Silicon Anomaly List

ADSP-21369

ABOUT ADSP-21369 SILICON ANOMALIES

11. 08000024 - Parallel EPROM/FLASH boot following a Hard (Hot) Reset may fail if issued in the middle of external SDRAM reads:

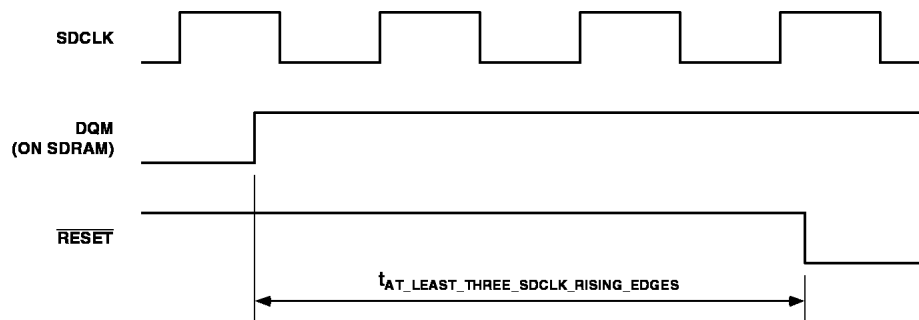
If the SHARC processor is in the process of fetching data from external SDRAM memory, initiating a Hard (hot) reset during this process may cause the SDRAM device to continue to drive the data bus during the entire duration of /RESET being asserted, and also failing to relinquish the external data bus even when the DSP comes out of /RESET.

If the DSP had been configured to boot via parallel external FLASH or EPROM (which shares part of the same data bus with the external SDRAM), the resulting bus contention on the external data bus between the DSP trying to boot from the FLASH memory and the SDRAM continuing to drive the data bus causes incorrect boot data to be loaded in, and the booting operation fails. Once the above state is hit, subsequent DSP Resets will not correct the situation. A power-cycling sequence is required to recover from this state.

Providing an external delay of at least 3 SDCLK clock cycles between the SDRAM's DQM signal and the /RESET_IN to the DSP will also cause the problem to be avoided (see attached Figure).

Configure the DSP to boot via SPI port (master or slave) and perform the following sequence within the loader kernel:

- Initialize the SDCTL and SDRRC registers to the appropriate values
- Perform a dummy read access of external SDRAM memory.
